Subject: Colusa Generating Station Project (06-AFC-9C)
Response to Data Requests 1-17 Related to PG&E's License Petition Amendment

Colusa Generating Station

Data Responses

(Responses to Data Requests 1 through 17)

FIGURE 16-1A
COLUSA GENERATING STATION
WATER BALANCE
 COLUSA GENERATING STATION
 PACIFIC GAS AND ELECTRIC

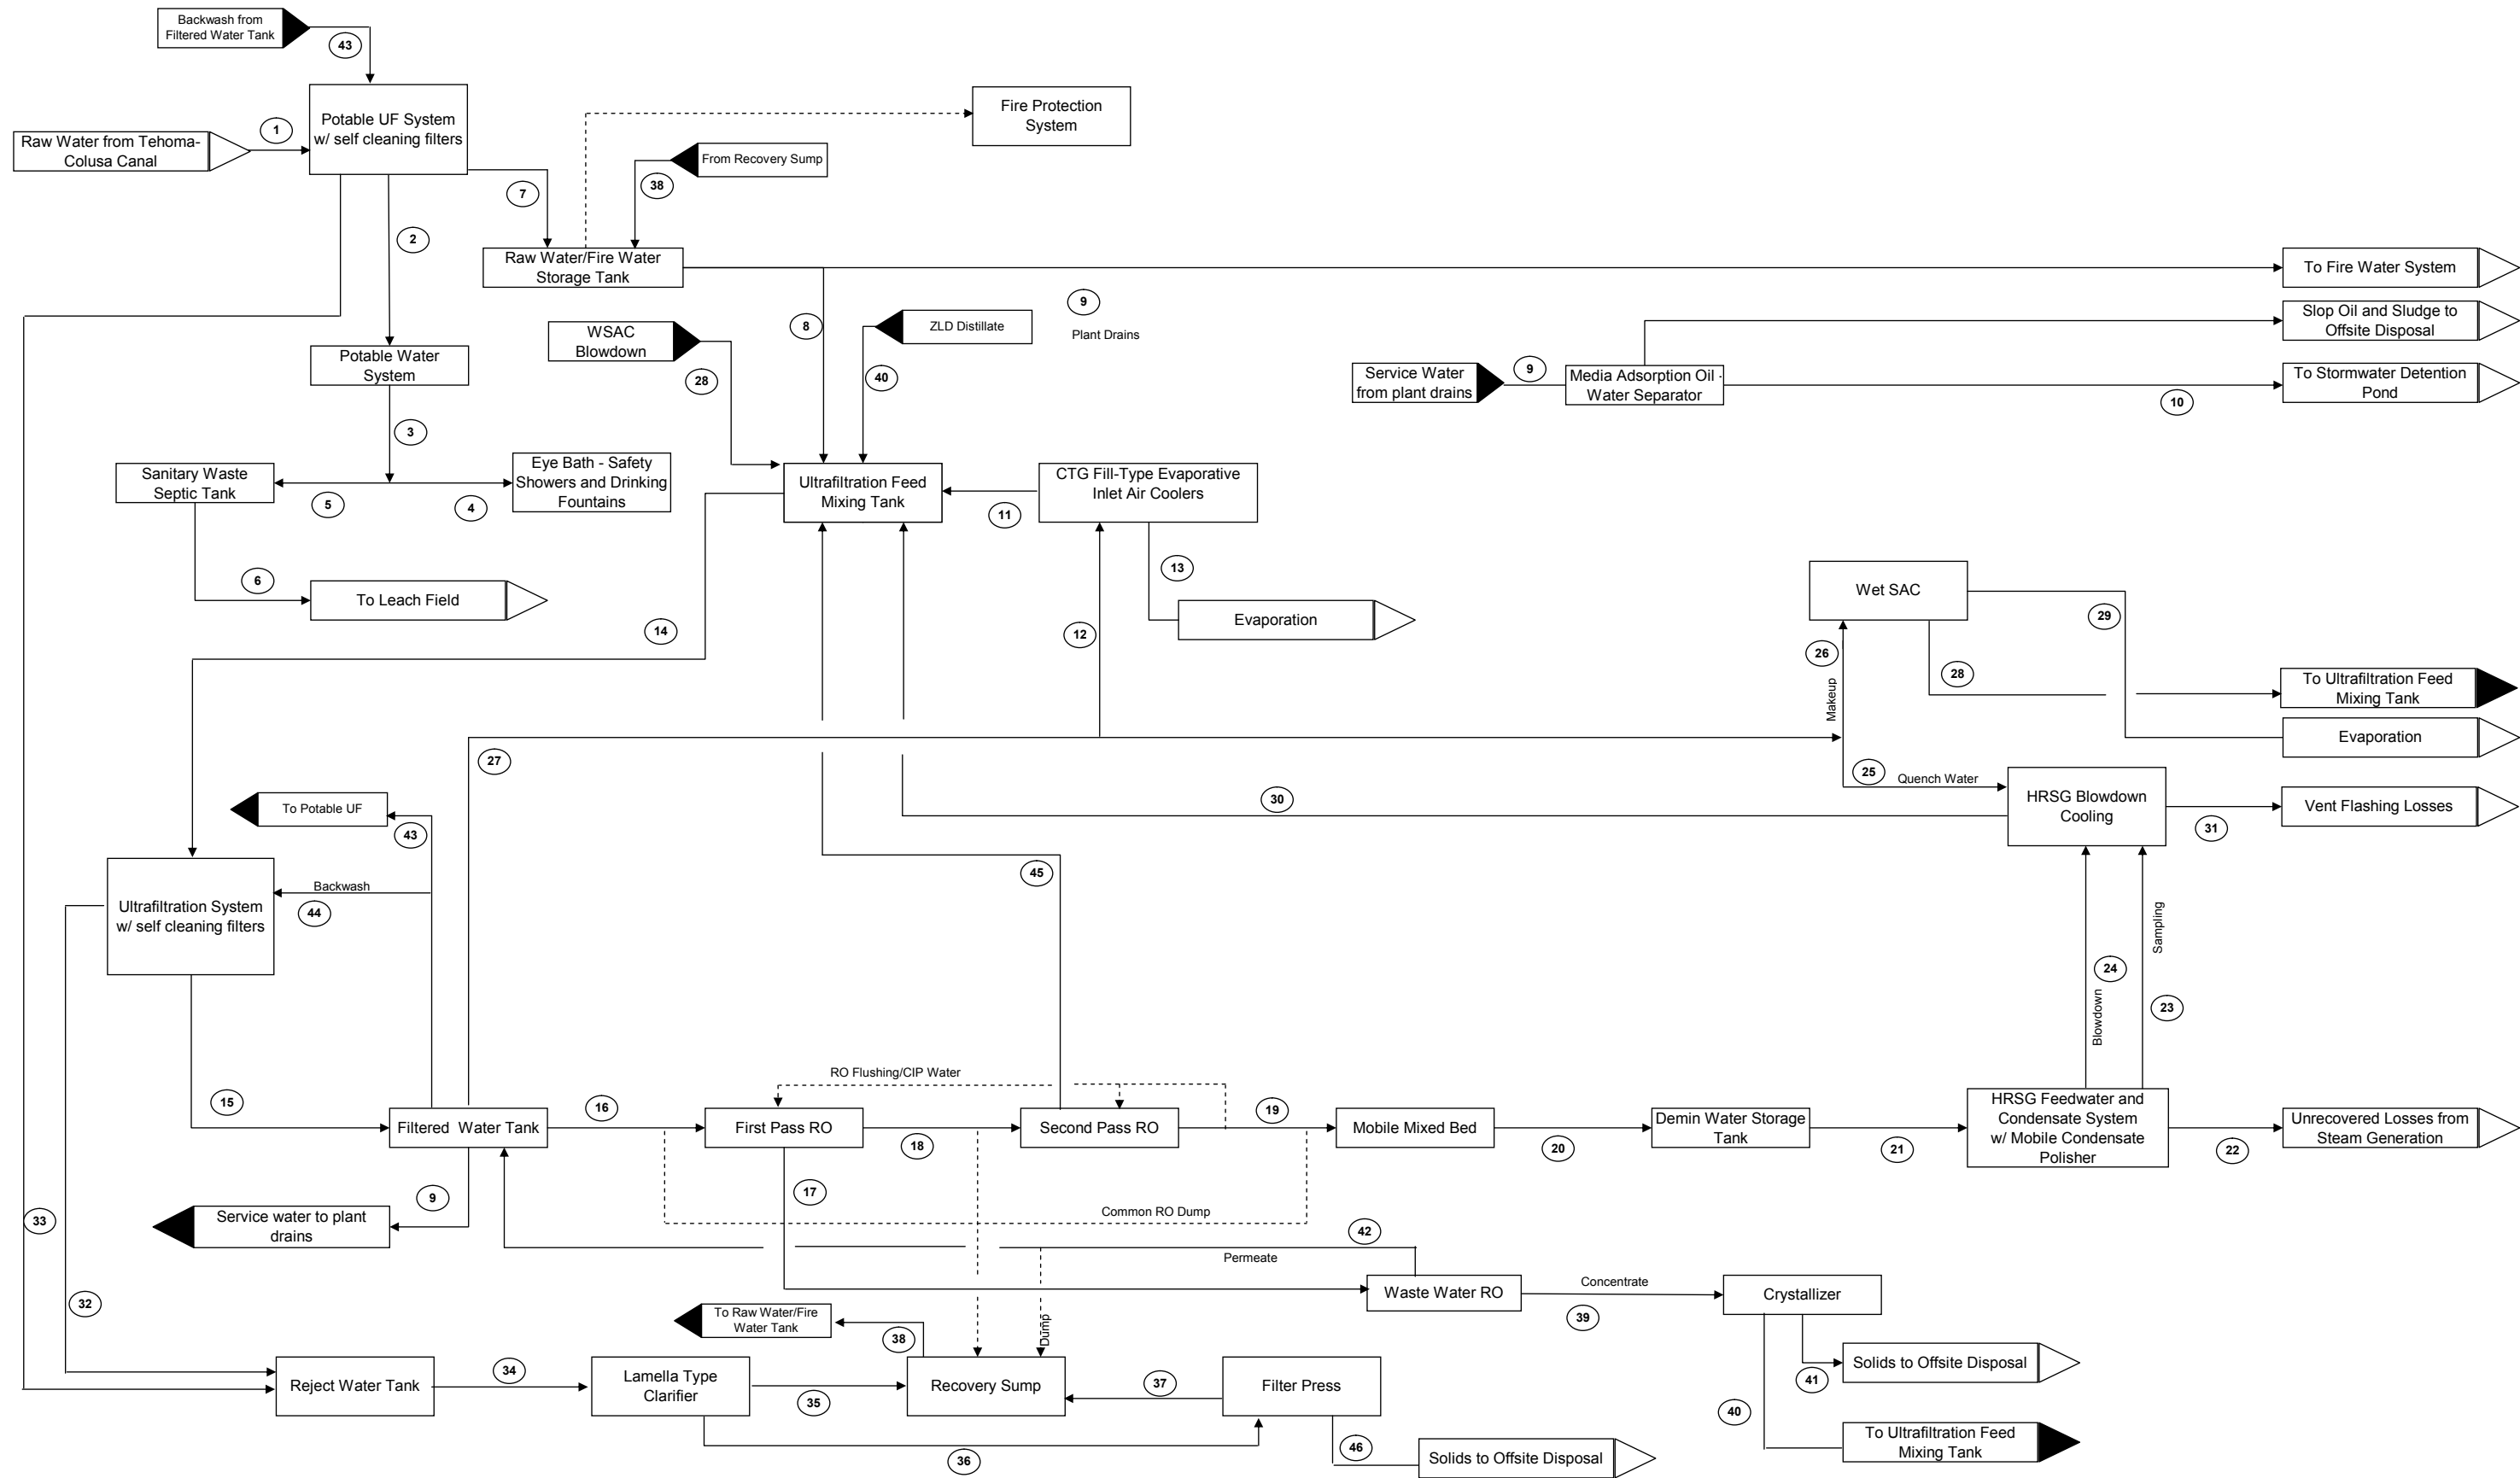
PG&E has provided a revised water balance diagram as Figure 2-4 that includes the WSAC system but did not provide a water balance table that identifies the flow rates corresponding to the processes shown on Figure 2-4. Additionally, the natural gas water bath heating system is not shown on the water balance diagram and its flow rate and annual water consumption are not identified.

16(b). Please provide: water balance diagram(s) that shows the flow distribution to the WSAC and the natural gas water bath heating systems and a table that identifies the flow rates for the processes shown on the diagram(s).

Response: Figures 16-1a and 16-1b presents a water balance diagram for the CGS project, showing the flow rates for all water consuming equipment.
